PLANNING & ZONING AGENDA ITEM #6

SUBJECT: Approval of a Site Plan Amendment for Stivers Ford

RE: Stivers Ford – Site Plan Amendment

RE: Stivers Lincoln Ford Site Plan

SITE PLAN STIVERS LINCOLN FORD

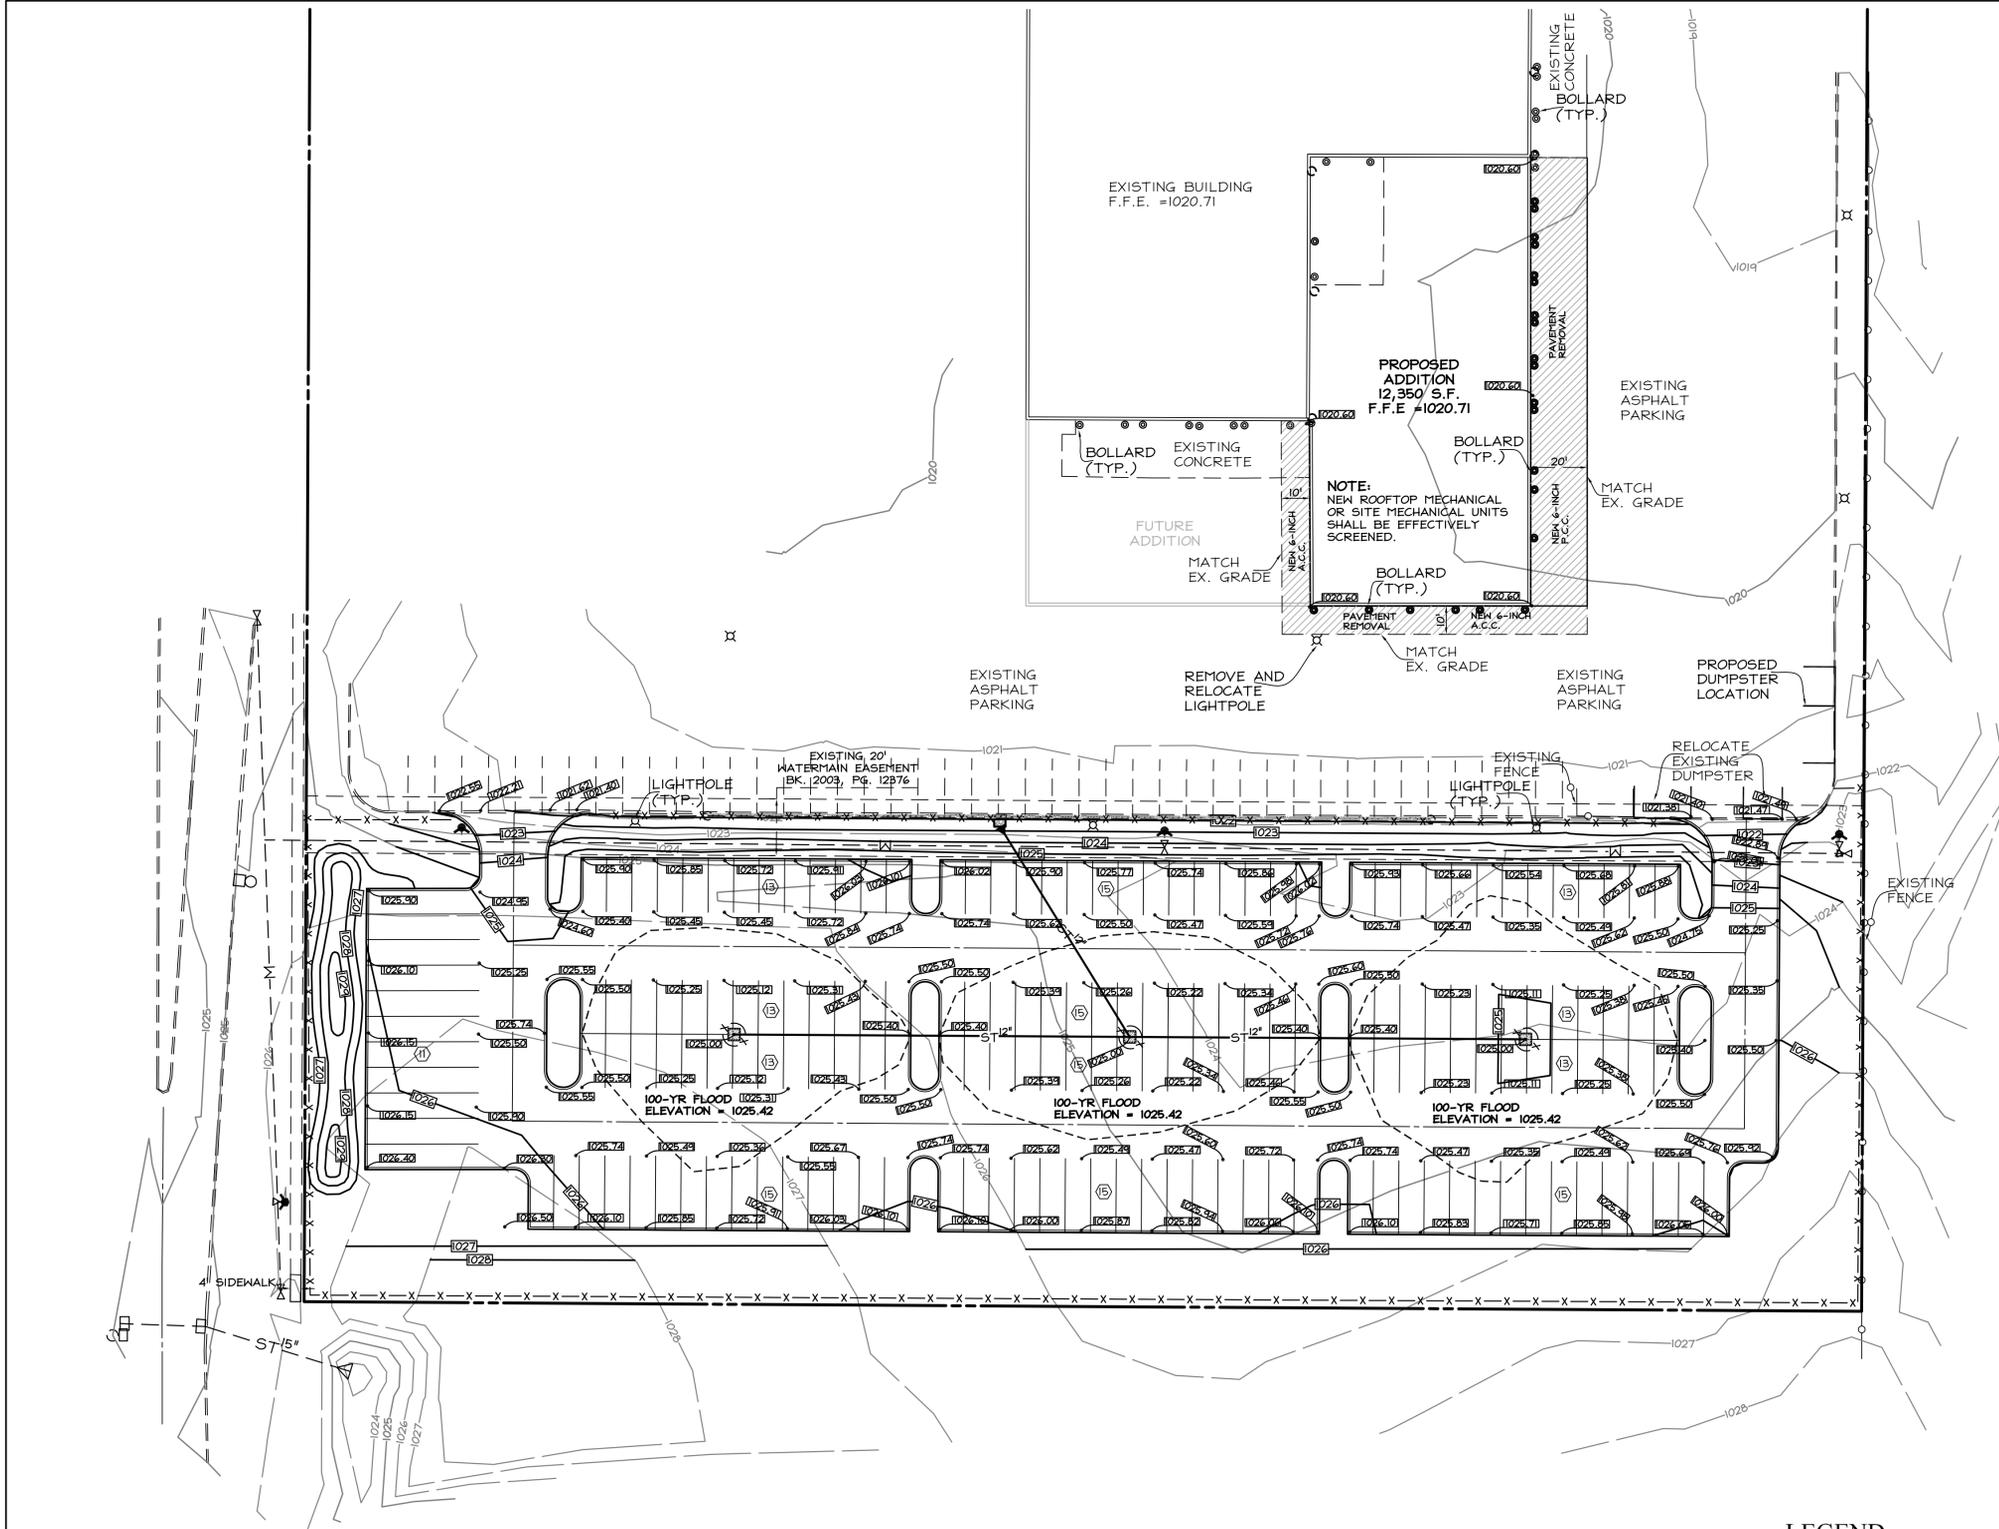
5. The vicinity sketch references SE Stonebridge Drive. This should be revised to SE Stoneridge Drive.
6. Staff questions how the existing parking and driveway aisles will be reconfigured based upon the proposed building addition. Please identify on the site plan.

7. The Zoning Ordinance requires a minimum 25 foot parking setback for parking lots abutting a residential use. This is applicable along the south and east property lines. The parking lot layout will need to be adjusted accordingly.

8. The parking lot setback requirement adjacent to the public Right of Way is a minimum of 10 feet.
9. The northern row of parking within the proposed parking lot addition could be reduced to 17 foot long stalls in order to save two feet of pavement costs based upon the proposed parking island.

10. The site plan ordinance requires that all parking aisles be provided with a terminal landscaped island that is a minimum of 10 feet in width. The proposed center parking aisles will need to be revised to reflect this requirement.

11. A maximum of 15 stalls are allowed within any aisle before a landscaped island is required. The proposed parking in the southwest corner of the property shows 16 stalls. Please revise.

12. A minimum of 50% of the proposed islands are required to have an overstory tree in them.

13. Berming should be provided adjacent to the parking that abuts SE Waco Place. Staff would also suggest some berming be introduced along the south and east property lines which abut residential developments.

14. Shrubs should be introduced in front of the parking adjacent to SE Waco Place to provide additional headlight screening.
15. A 30 foot landscape buffer is required between commercially zoned property and R-3 zoned property to the south. The City has recently approved a site plan for the adjacent property to the south and a portion of the landscape buffer is being provided as a part of that development. Based upon the length of the property being 550 feet, a total of 22 overstory trees, 33 evergreens and 22 ornamental trees are required. A total of 11 overstory trees and 22 evergreens are being provided as a part of the site plan of the property to the south. The remaining minimum requirements (11 overstory, 11 evergreens and 22 ornamental trees) will need to be provided as a part of this site plan.

18. One overstory tree per 40 lineal feet is required along SE Waco Place for the proposed parking lot addition. Based upon 170 lineal feet, four trees are required. This can be in lieu of and not in addition to the crabapple trees currently proposed on the plans.

19. Staff questions the location of the relocated existing dumpster. Additionally, staff questions what materials will be used for the relocated enclosure. A detail should be provided.

20. The existing lightpole shown just south of the proposed addition should be noted to be removed.
21. Staff questions if any additional wall mounted lighting is proposed to be used.

22. The location of proposed bollards for the addition should be indicated on the site plan.
23. A building material sample of the proposed building materials should be provided at the Planning and Zoning Commission.
